CITY OF PORTLAND, OREGON

Staff Presentation to the  
**Portland Design Commission**

**Design Advice Request**  
**EA 15-248752 DAR**  
**NW 14th & Glisan**

January 7, 2016

**Exterior Materials**

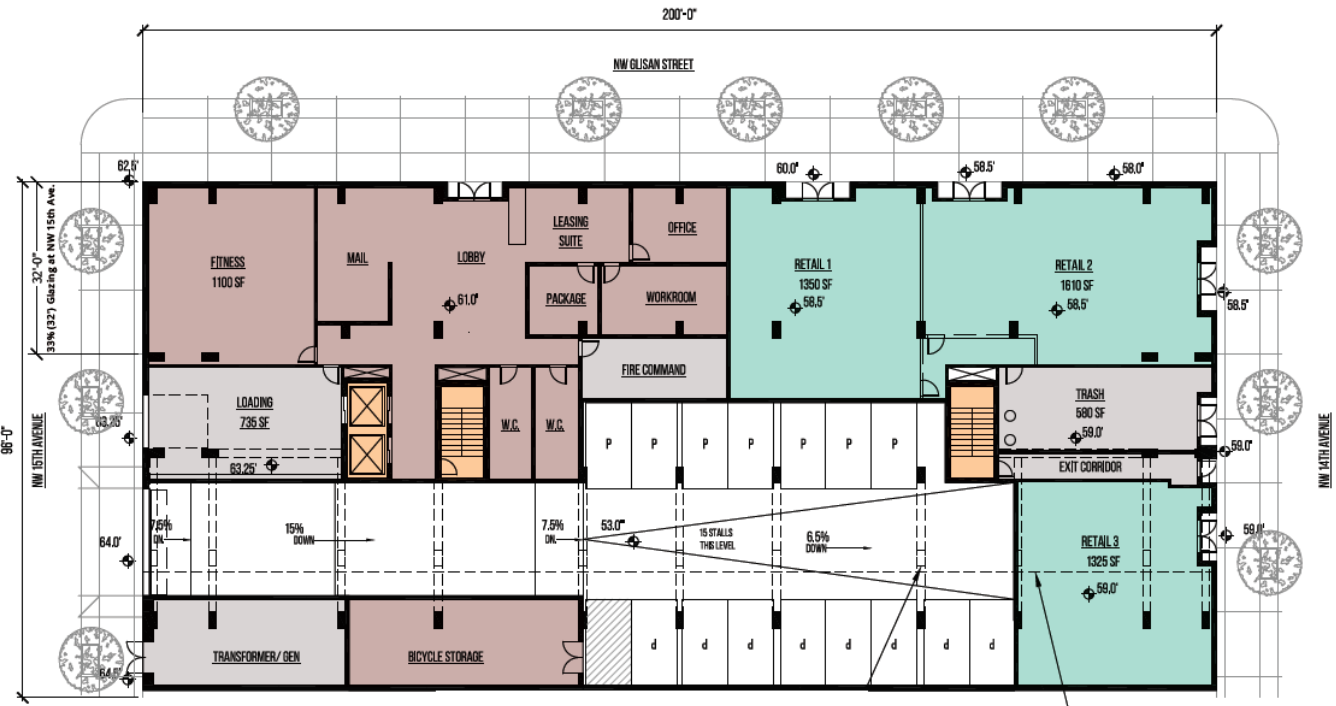
Primary - masonry (pre-cast concrete panels & brick) – used in neighboring historic and Pearl districts.

Aluminum window wall system & storefront, steel siding, glass railing

All materials appear to be durable and of high quality

## Ground Level

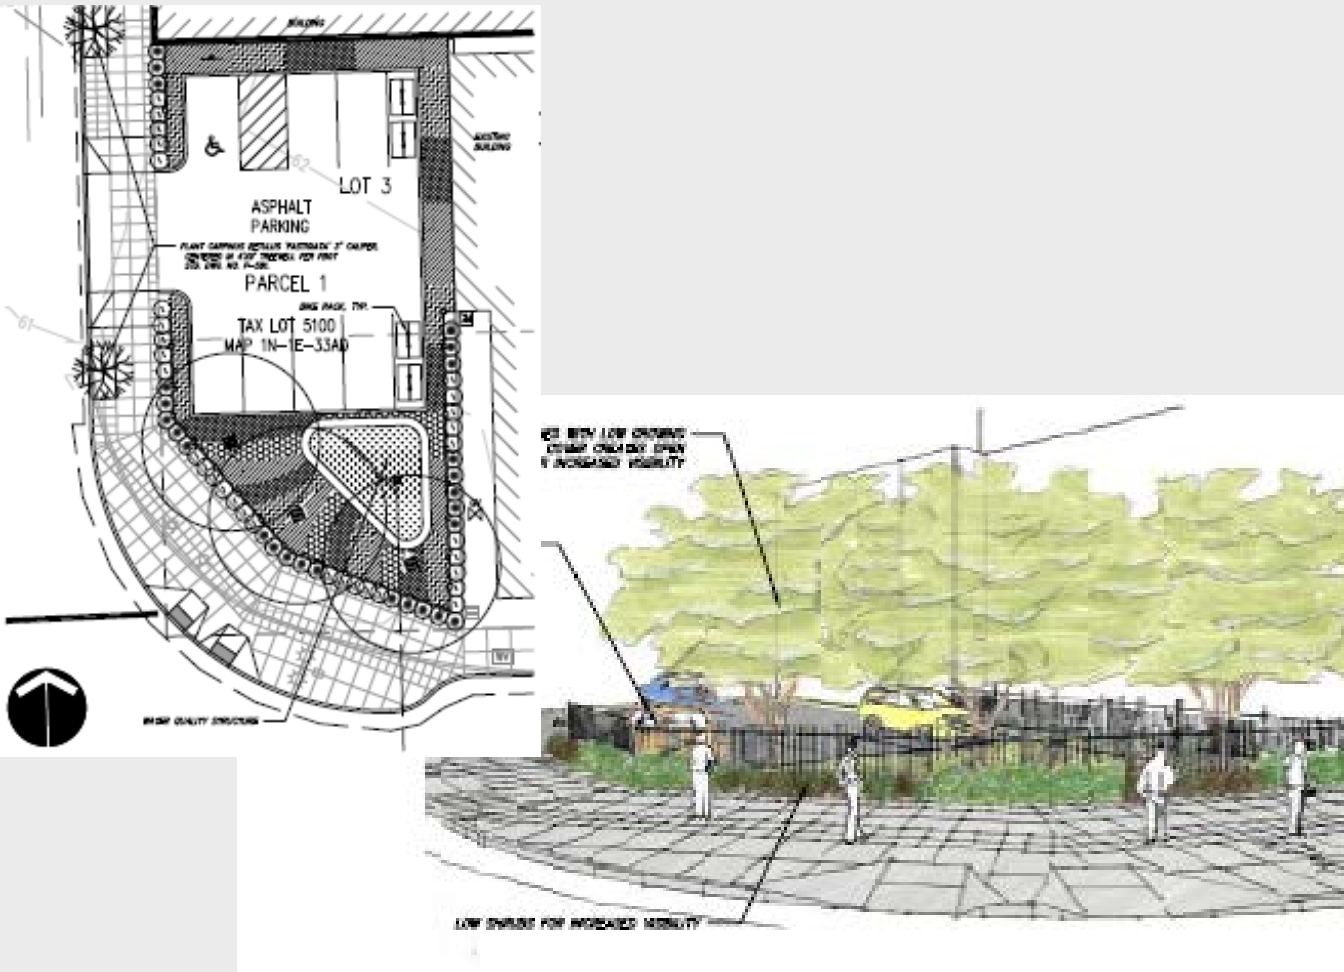
- Along 15th, reduce ground floor windows (50% to 32%)
- Electrical transformer in building south of garage entry
- Trash room along 14th – incorporated along 15th?
